Applicant	NOKIA CORPORATION		Field of Examination	Date of Issue
Agent	China Patent Agent (H.K.) Ltd.			December 5, 2003
Patent Application No.	01809019.2	Application Date	May 2, 2001	Examination Report
Title of Invention	REMOVABLE HOUSING COVER FOR A PORTABLE RADIO COMMUNICATION DEVICE

First Office Action

Text of the First Office Action

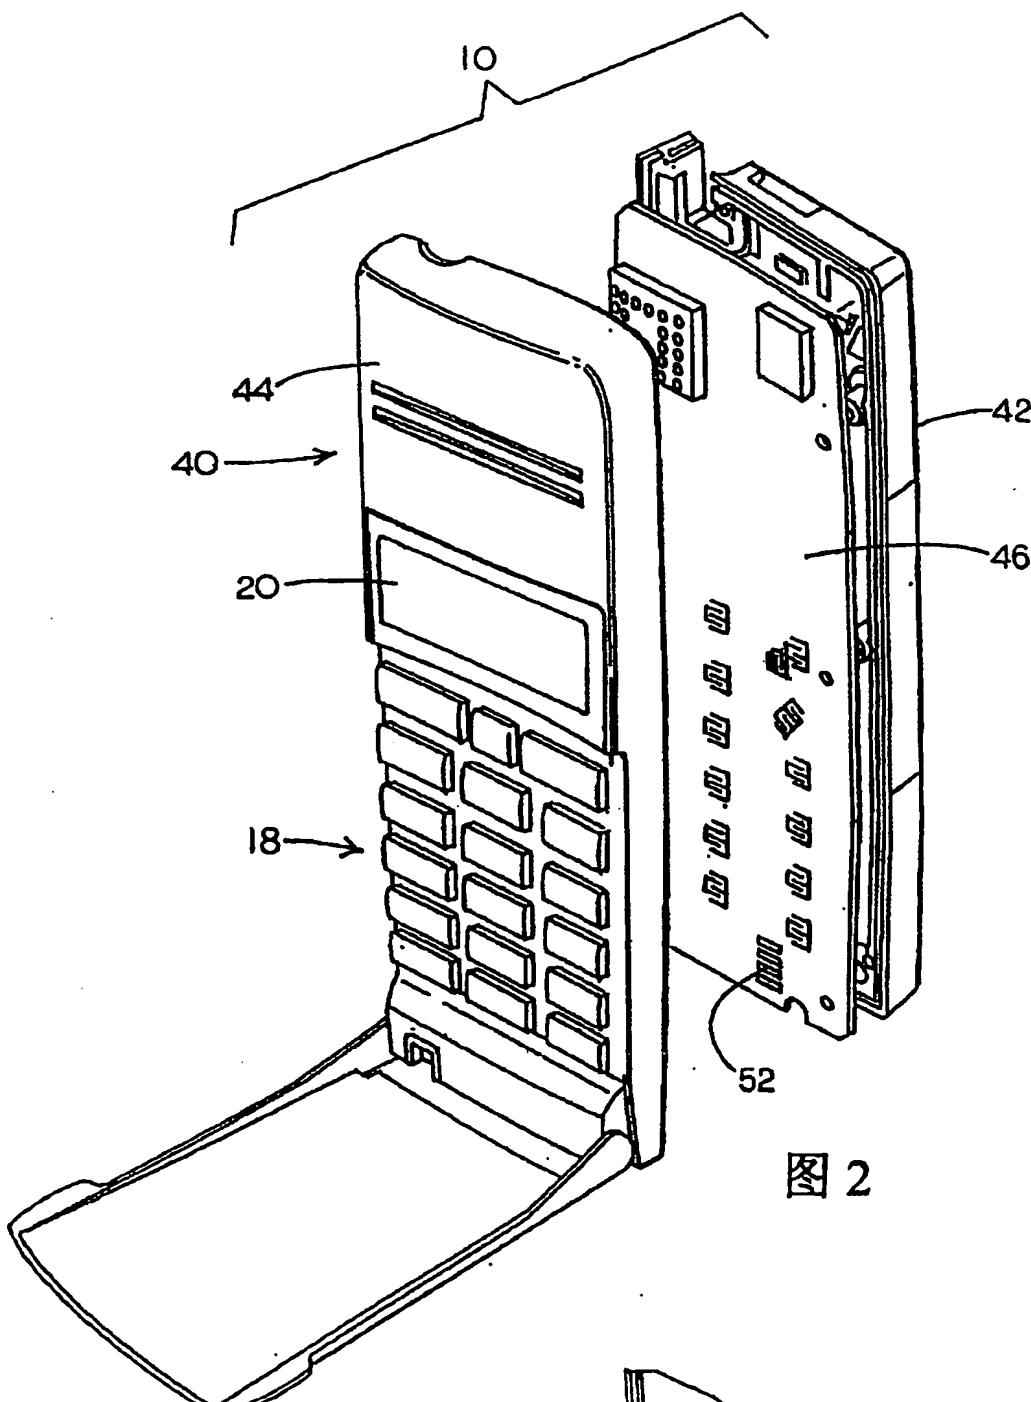
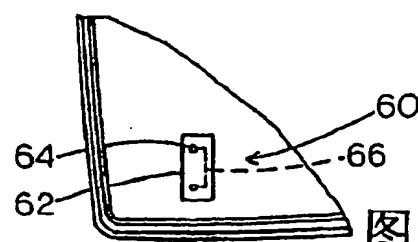
1. Claim 1 claims a removable housing cover adapted to be detachably connectable to a portable radio communication device. Reference document 1 (CN1220060A) (see line 28, page 2 to line 25, page 7 of the description and Figs.1-3 and 6-9) has disclosed an interchangeable front cover (44) detachably connectable to a mobile telephone (10), wherein said front cover has a program selector (60, equivalent to the identity means in said claim) associated therewith; said mobile telephone comprises a detection circuit (50) serving as a sensor for sensing the program selector of the cover, and a microprocessor (12) for controlling the operating characteristics of said telephone; when said cover is mounted on the mobile telephone, said sensor senses said program selector and transmits the sensed data to the microprocessor, thereby said processor is enabled to determine the selected program configuration so as to change some selected operating characteristics of the mobile telephone by using the configuration signals read from the detection circuit (50). Thus, it can be seen that the technical solution disclosed in reference document 1 is slightly different from that claimed in claim 1 in expression, but they are the same in substance. Besides, they are of the same technical field, intended to solve the same technical problem and capable of producing the same technical effect. Therefore, claim 1 is contrary to the provision on novelty of Article 22, para. two, of the Patent Law.

9. Claim 11 claims a housing cover. Reference document 1 (CN1220060A) (see line 28, page 2 to line 25, page 7 of the description and Figs.1-3, 6 and 8) has also disclosed a cover (44), wherein it comprises an attaching means for detachably attaching the cover to the mobile telephone (10); a program selector (60) such that when the cover is mounted on the mobile telephone, the program selector is coupled with the detection circuit (50) serving as a sensor, wherein the internal functionality of the telephone is dependent on the program selector. Thus, it can be seen that the technical solution disclosed in reference document 1 is slightly different from that claimed in claim 11, but they are the same in substance. Besides, these two technical solutions are of the same technical field, intended to solve the same technical problem and capable of producing the same technical effect. Therefore, claim 11 is contrary to the provision on novelty of Article 22, para. two, of the Patent Law.

图 8

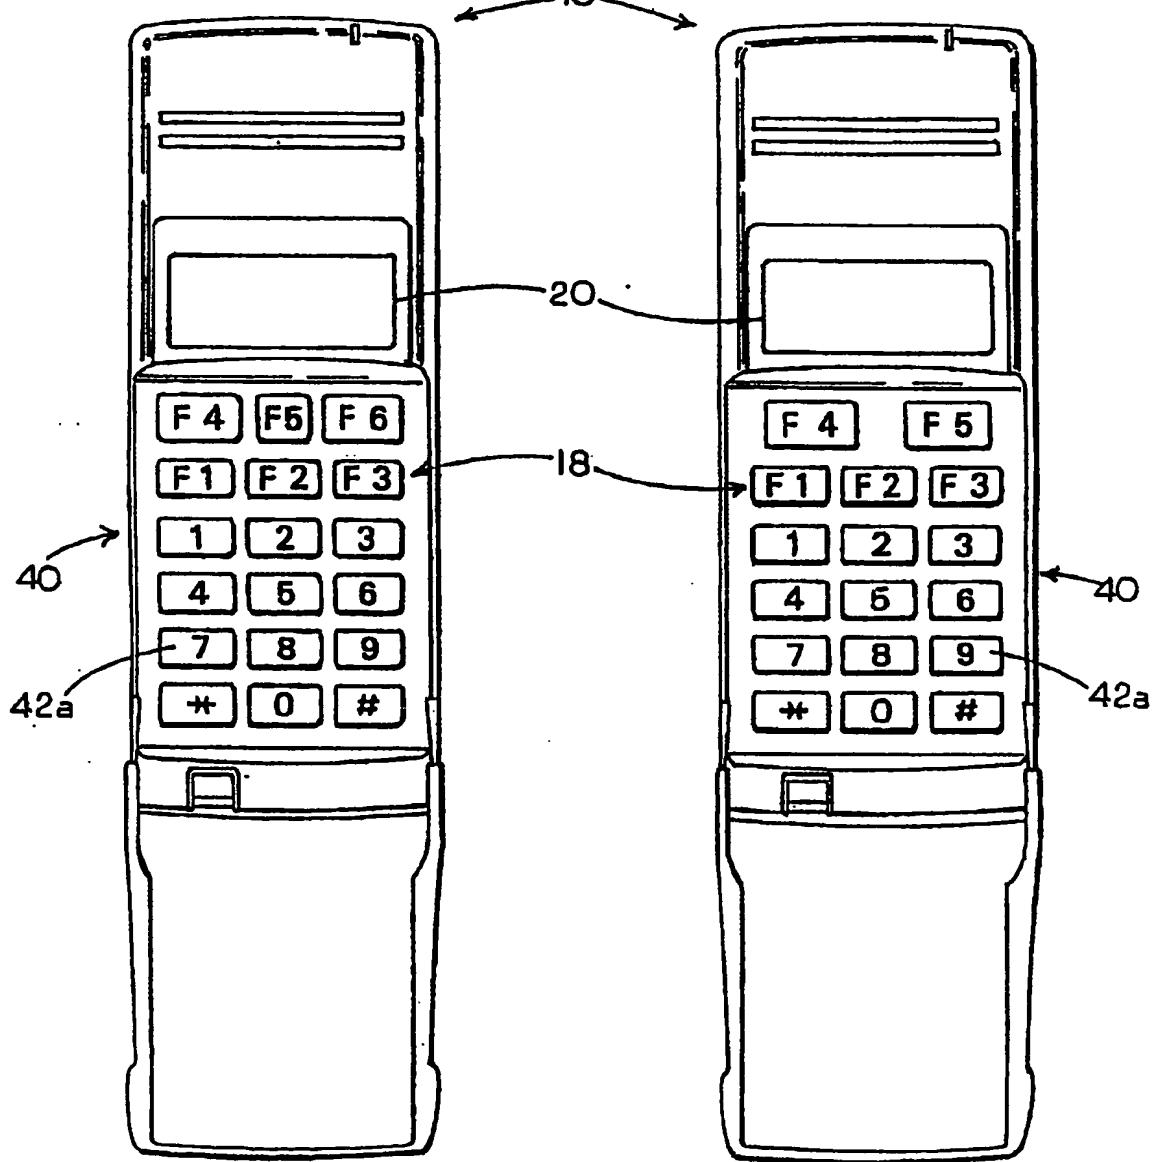
11. The additional technical features of claim 14 have been disclosed in reference document 1, wherein (see Figs.6 and 8) it is shown in Figs.6 and 8 that the quantities of function keys on the interchangeable covers are not uniform, so the covers can be differentiated from one another; besides said interchangeable cover covers all of the telephone. Therefore, when claim 1 to which claim 14 refers does not possess novelty, claim 14 does not possess novelty, either, so claim 14 is contrary to the provisions of Article 22, para. two, of the Patent Law.
